SUBJECT: CONTRACT NO. DE-AC04-94AL-85000 – CORRECTION TO ERROR IN
INFORMATION PRESENTED TO THE NUCLEAR WASTE TECHNICAL REVIEW BOARD
(NWTRB) ON MAY 29, 2008

Total System Performance Assessment: Modeling Approach and Overview of Results

**Corrected copies of
Slides 34 and 35**

Fraction of locations in each percolation subregion with the potential for localized corrosion (MDL-WIS-000005 REV 00 AD01 Fig O-2)

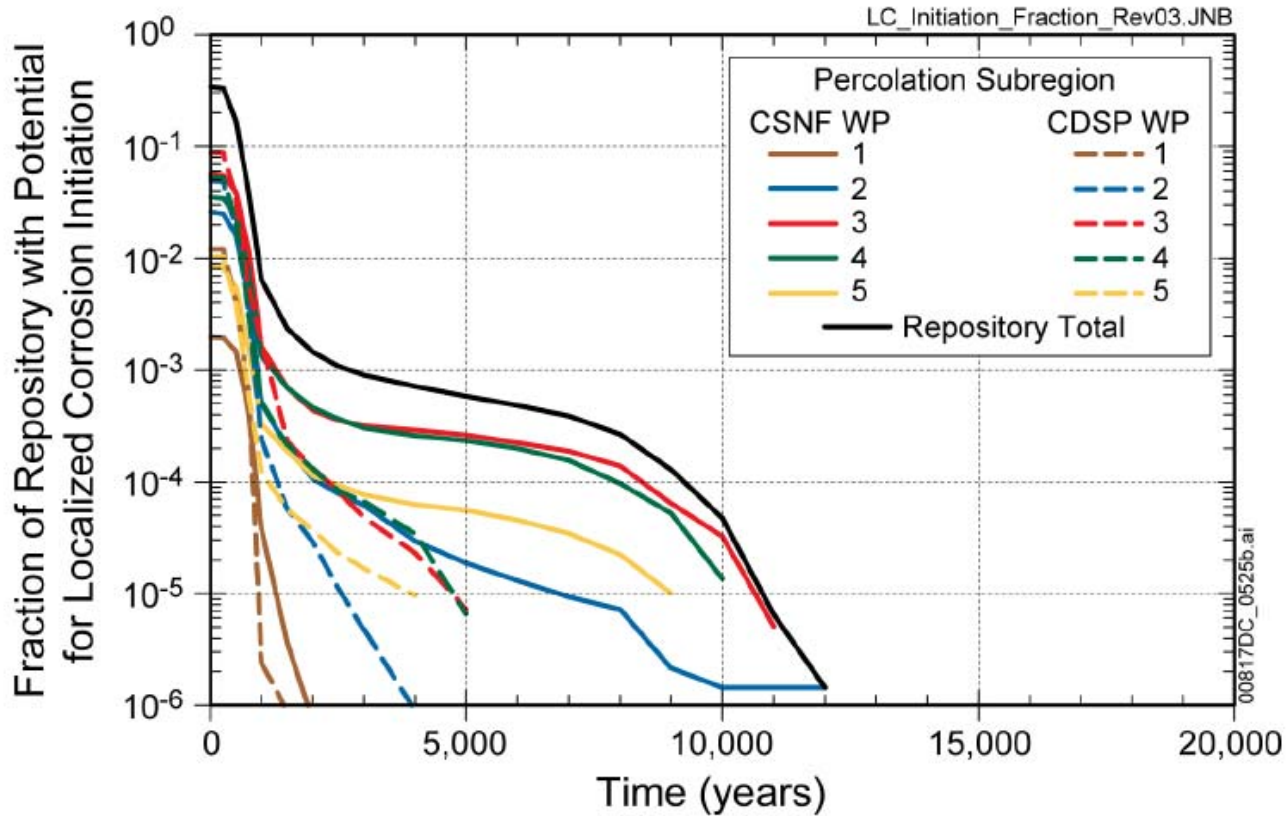
The correction changes the value calculated by the TSPA localized corrosion initiation analysis for the percentage of locations within the repository where environmental conditions could be favorable for the initiation of localized corrosion on Alloy 22, assuming that drip shields had failed. As reported in both my presentation to the Board and the TSPA-LA report, approximately 10% of the waste package locations could have environmental conditions favorable to the initiation of localized corrosion. Corrected results, as shown in the corrected copies of Slides 34 and 35, indicate approximately 34% of locations could have such conditions approximately 500 years after permanent closure of the repository. Conditions at later times, for example, at 5000 years, are unchanged.

The correction results from the implementation of the "salt separation" model in an updated set of localized corrosion initiation analyses. Although text in the TSPA-LA report (MDL-WIS-000005 REV 00 AD01, section 6.3.4.3.2) and the License Application Safety Analysis Report (the SAR, DOE/RW-0573 Rev 0, Section 2.3.5.5.1) describes this model, which allows chloride concentrations to increase due to physical separation of dissolved and precipitated phases as seepage water evaporates during flow on a hot metal surface, as having been used in localized corrosion analyses, the model had not been implemented in the calculations reported in Appendix O of the TSPA-LA report.

- ◆ LC conditions could exist at approximately **34 %** of modeled WP locations at early time
 - ◆ By 5000 years, less than 0.1 % of WP locations have LC conditions
